APOPKA DEVELOPMENT REVIEW COMMITTEE AGENDA

January 28, 2026 9:00 AM

1. **MDP-25-11 Sheeler Park MDP (fka 1920 Sheeler Avenue) - Major Development Plan (MDP), 2nd Submittal**

2. **MDP-25-9 Saddlebrook Meadows Subdivision - Major Development Plan (MDP), 2nd Submittal**

SHEET NUMBER
4 OF 23

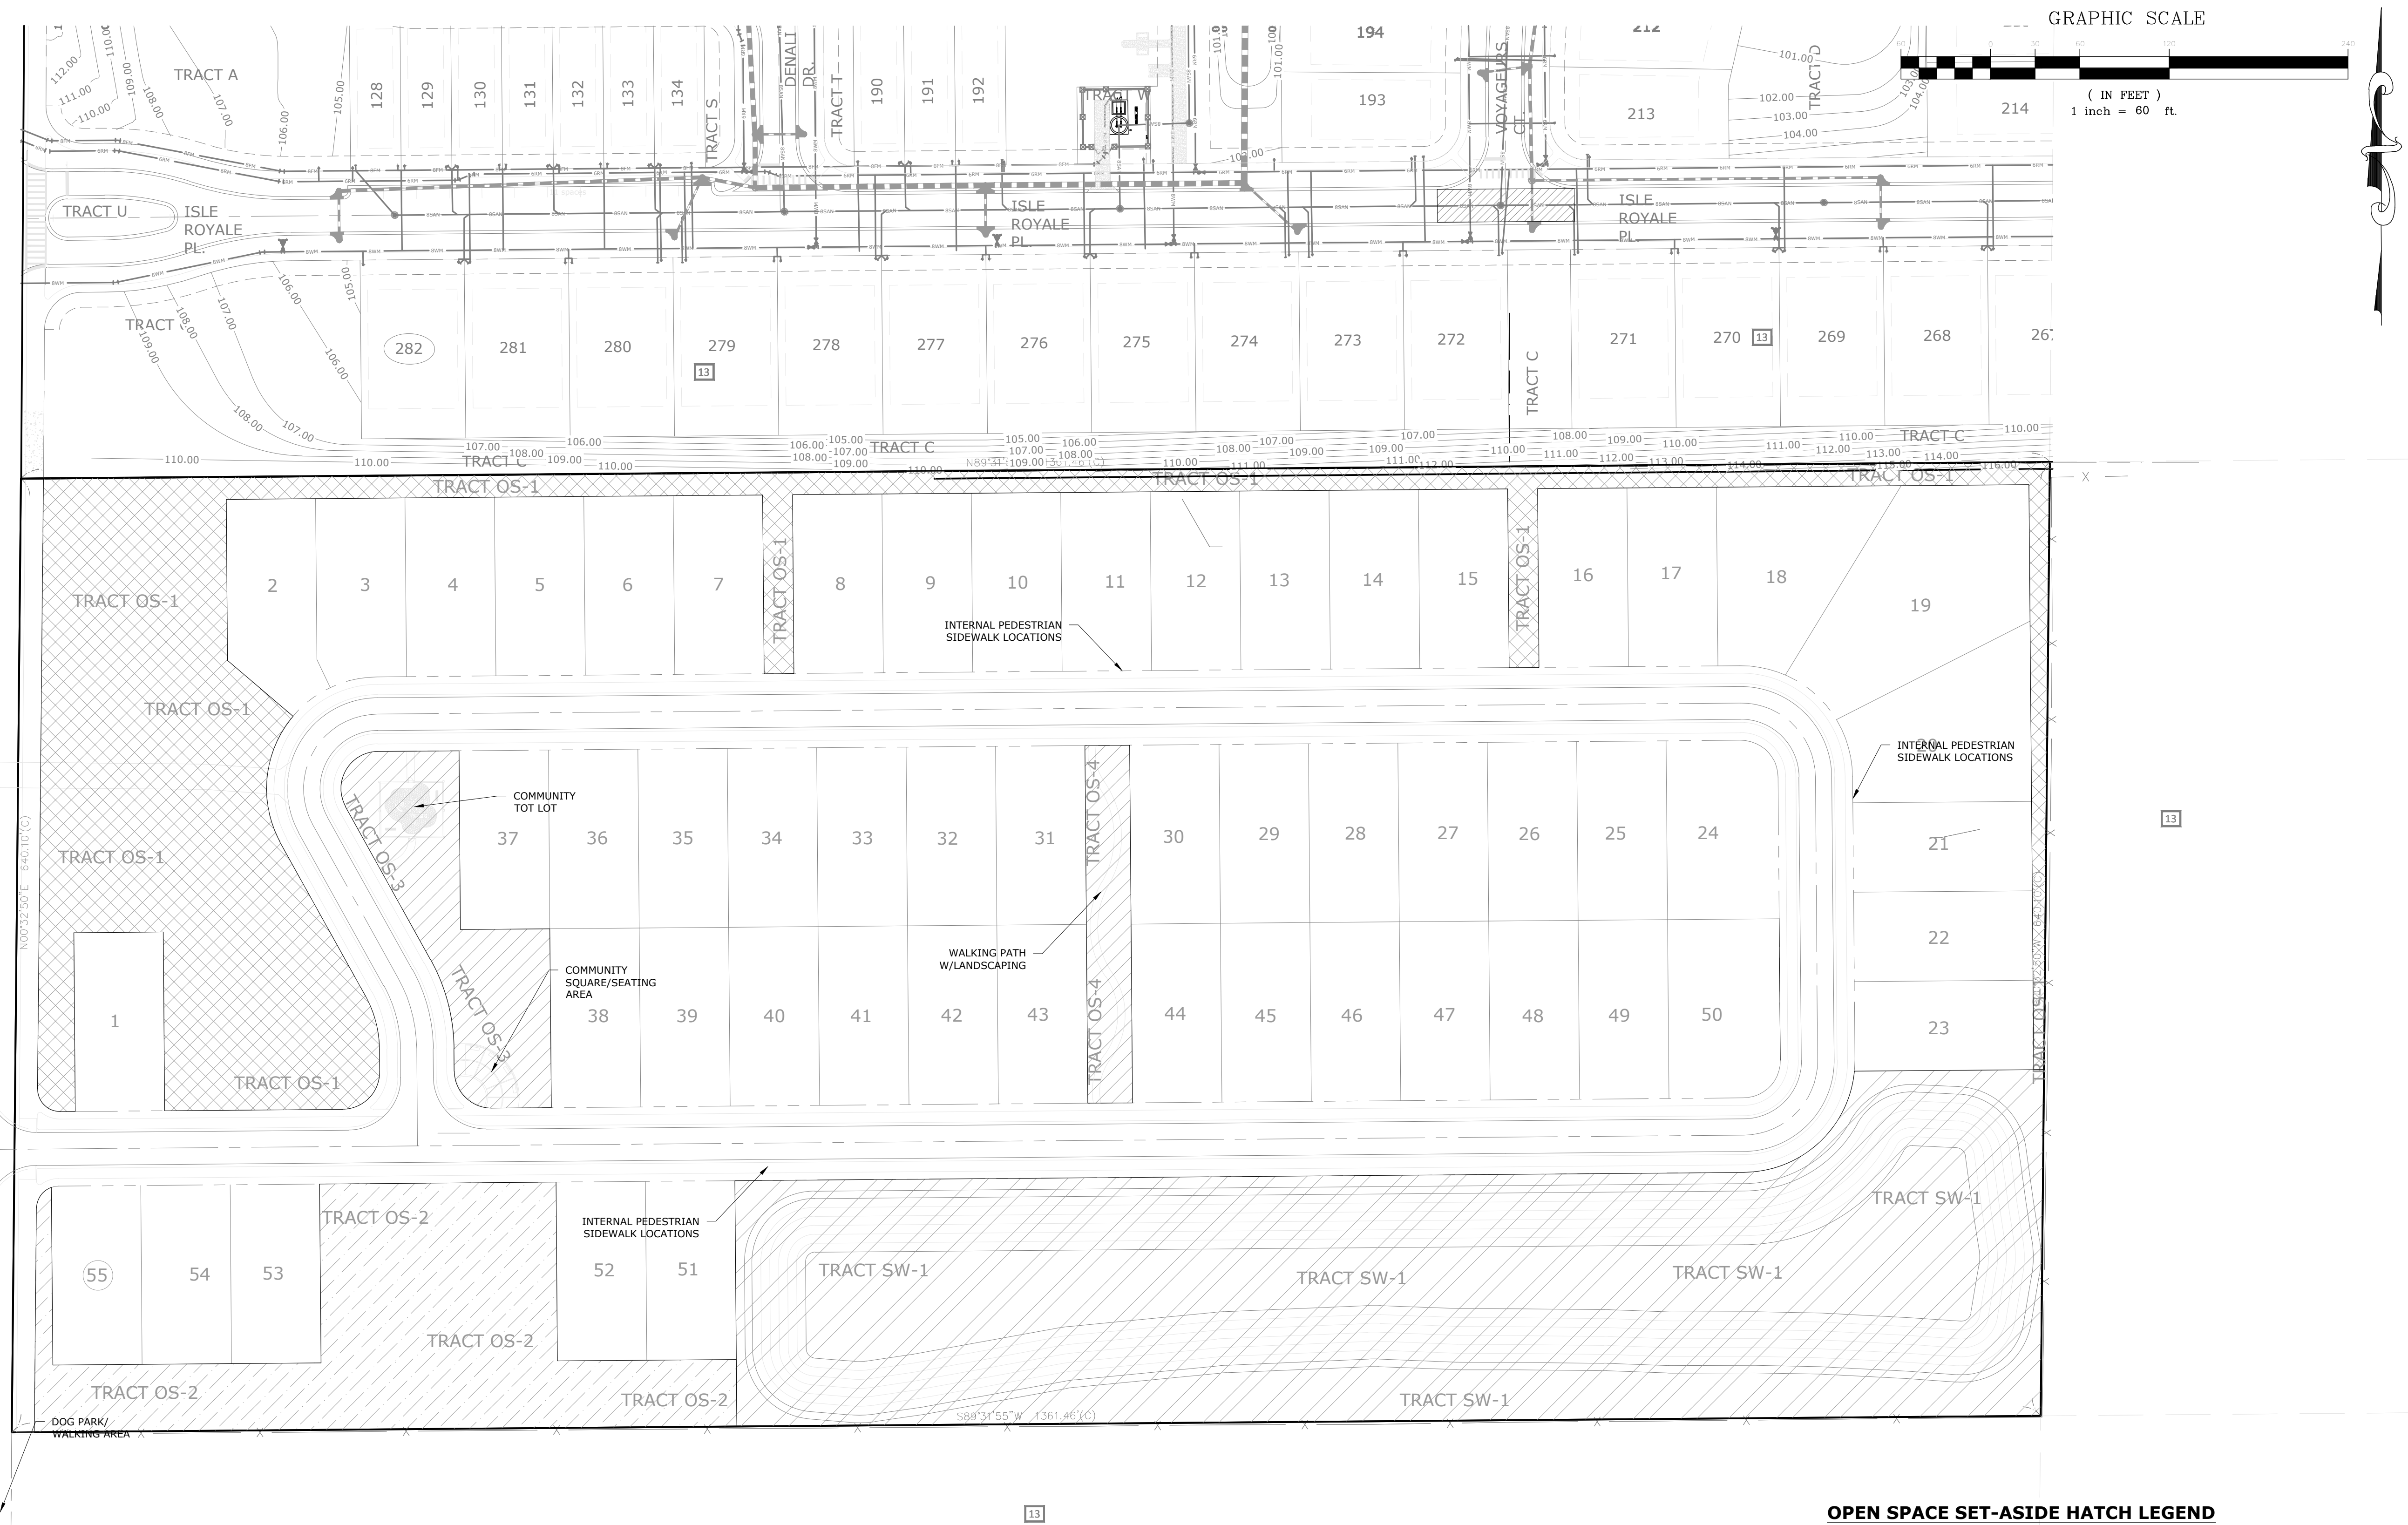
6. The notes on Sheet 4 state the parking is for townhome units, it appears that this is a single-family residential subdivision.

Response: Please see revised Sheet 4 which has been updated to correct the townhome reference and reflect single-family.

14 OF 23

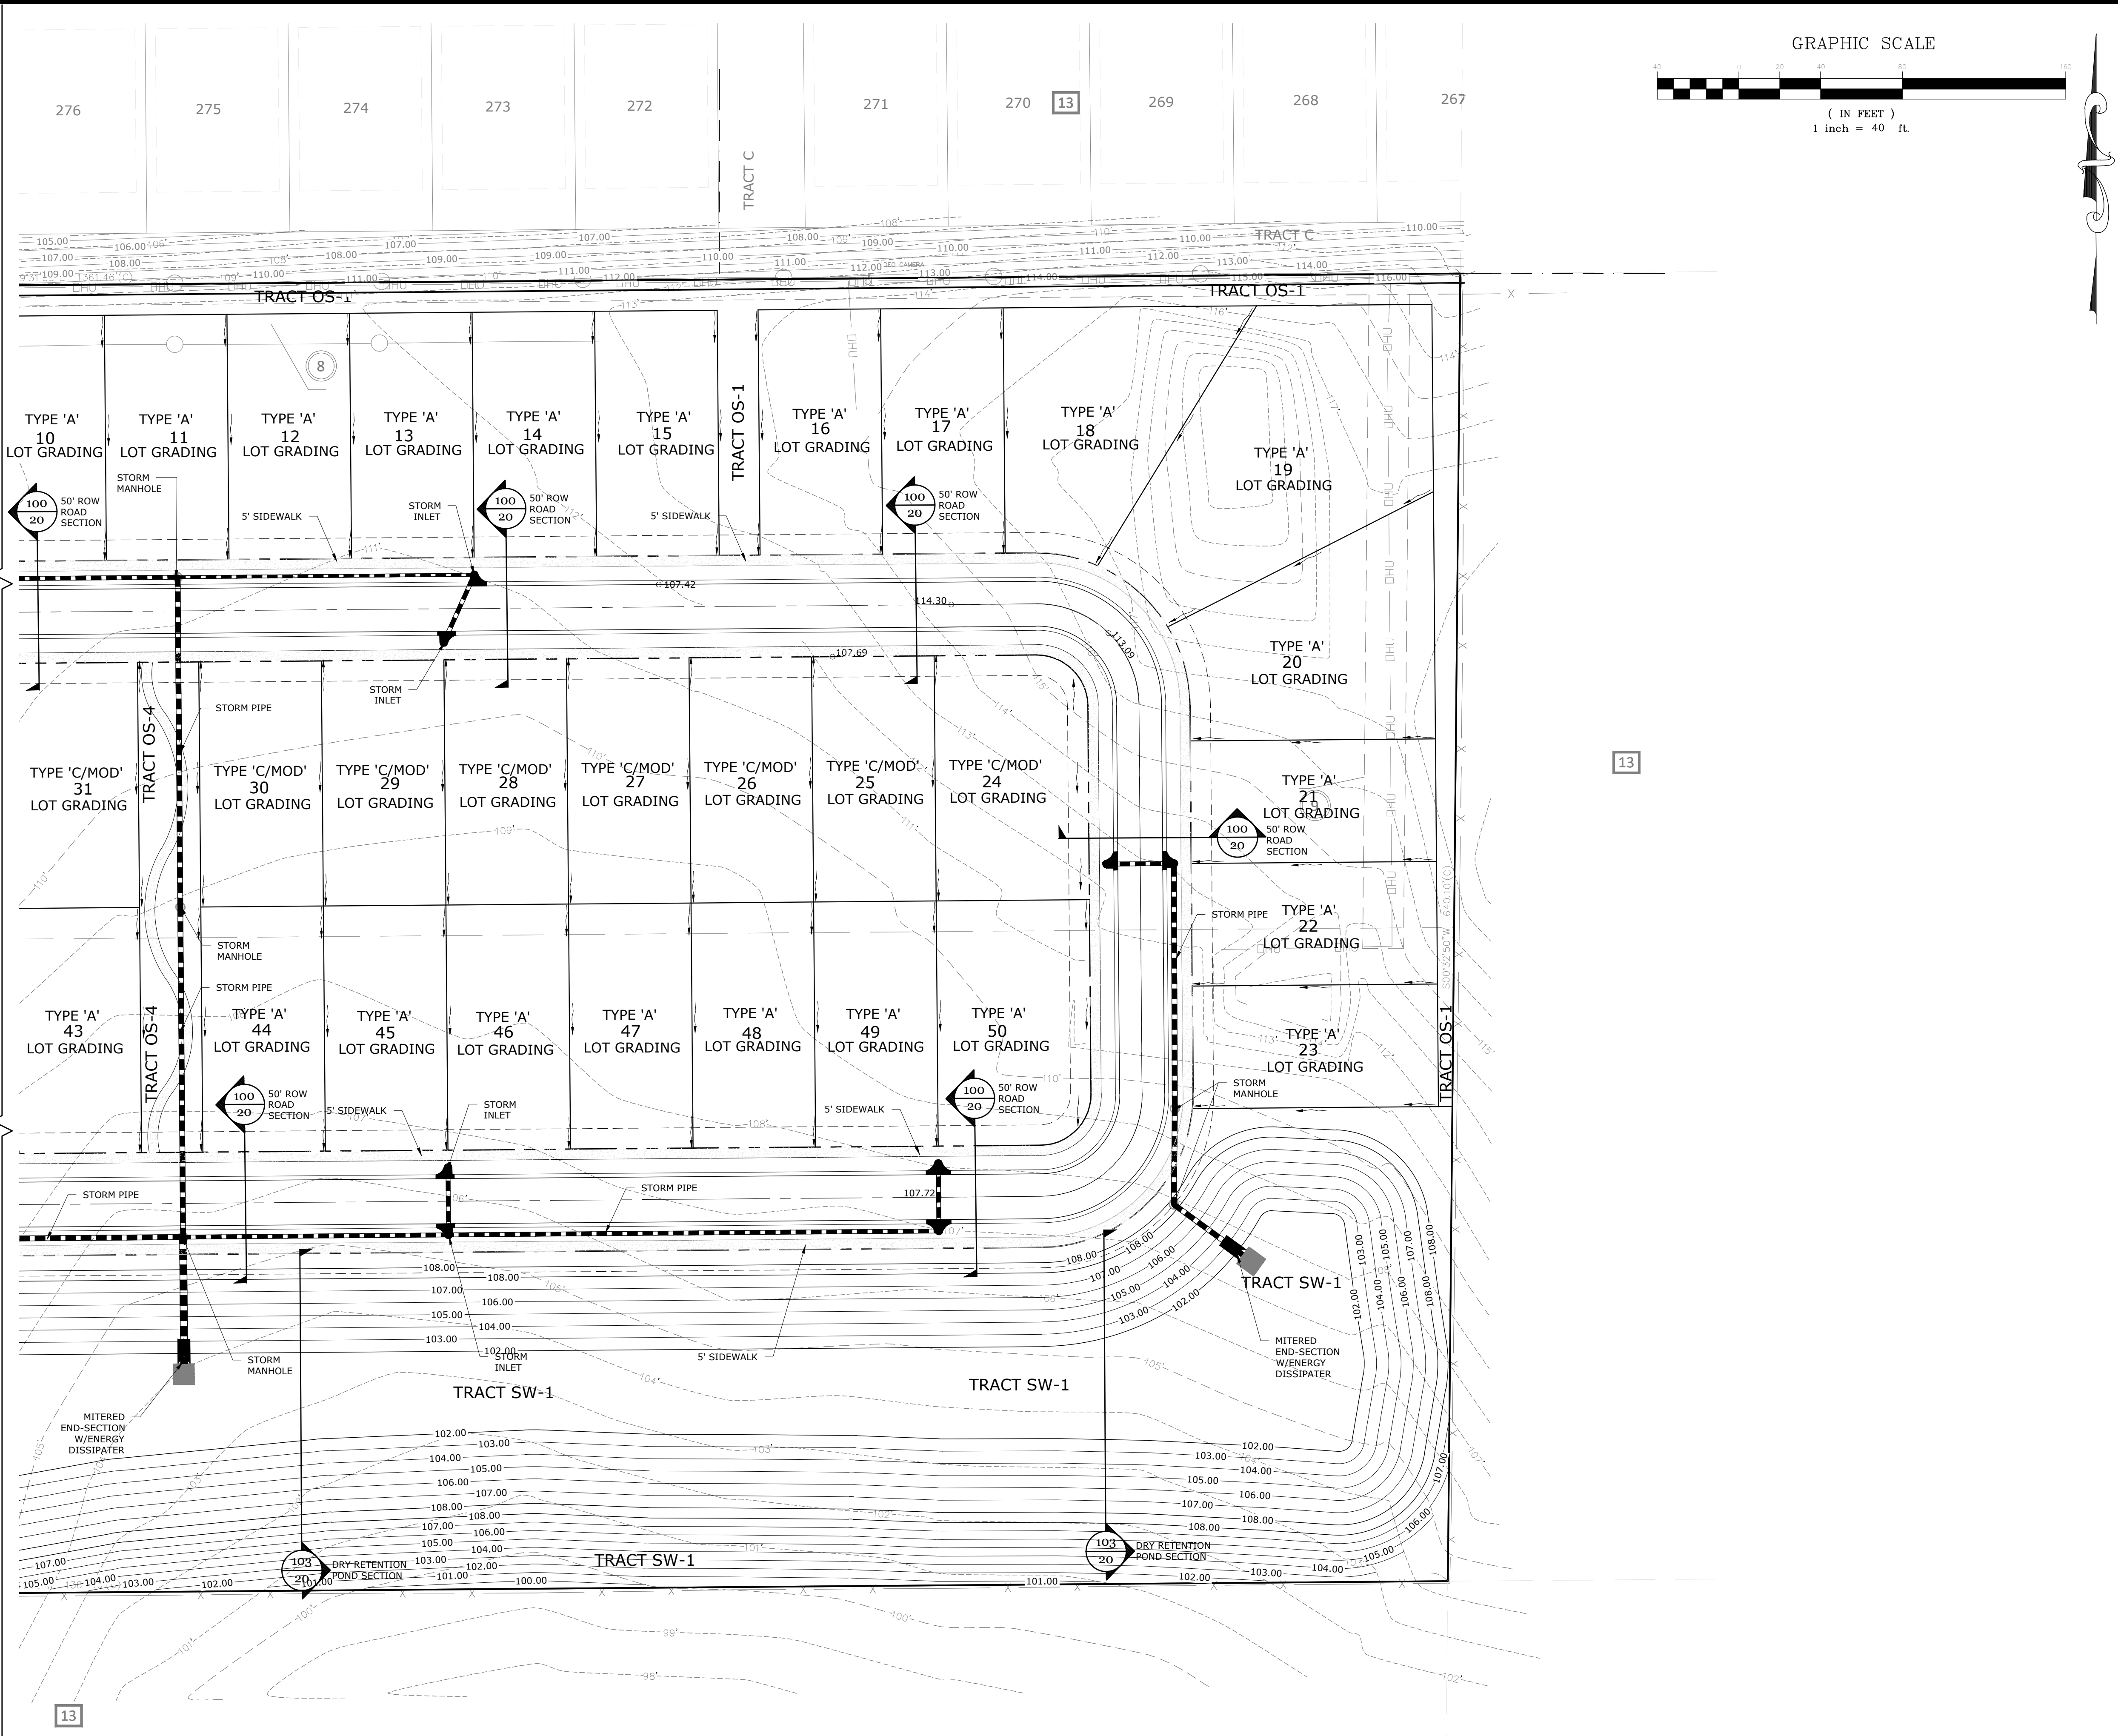
11. Show the back slope of the pond.

Response: Please see revised Sheets 14 and 15 for the pond back slope contours. The slope grades to a 4.2 to 1.

19 OF 23

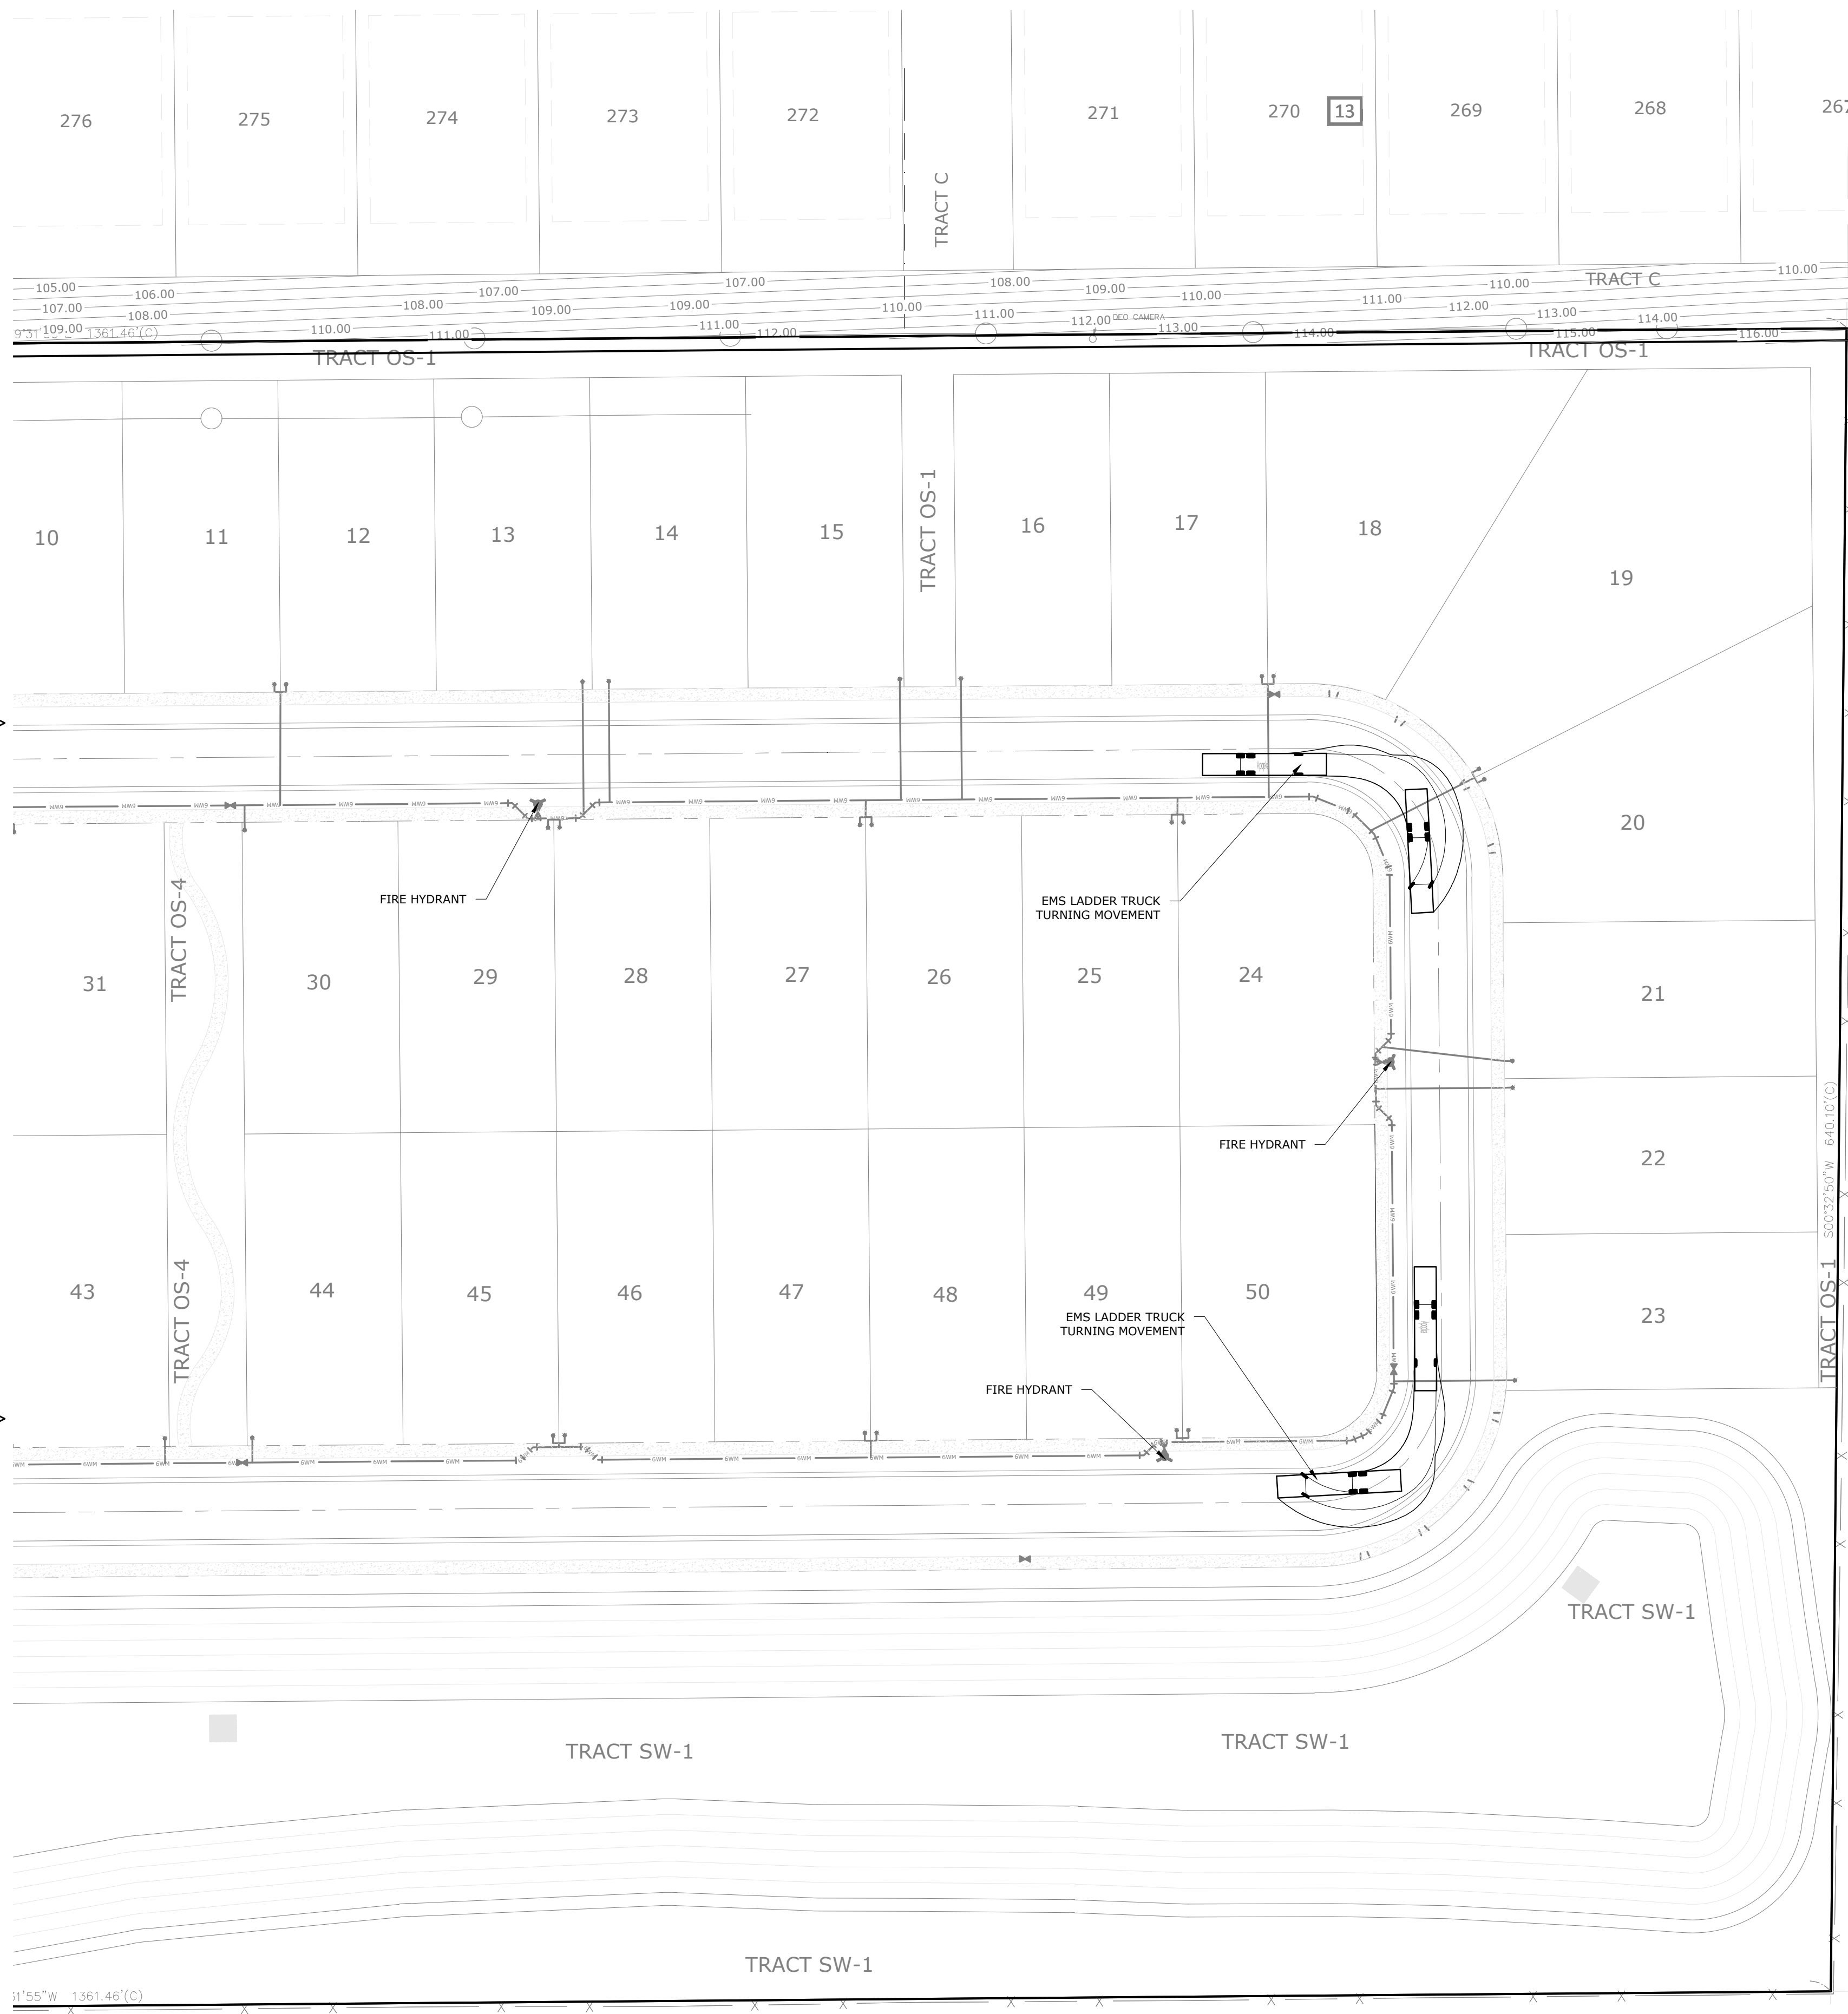
16. Provide a secondary emergency access.

Response: Please see revised Sheet 19 for the addition of the secondary access onto Golden Gem Road and through the power easement area.
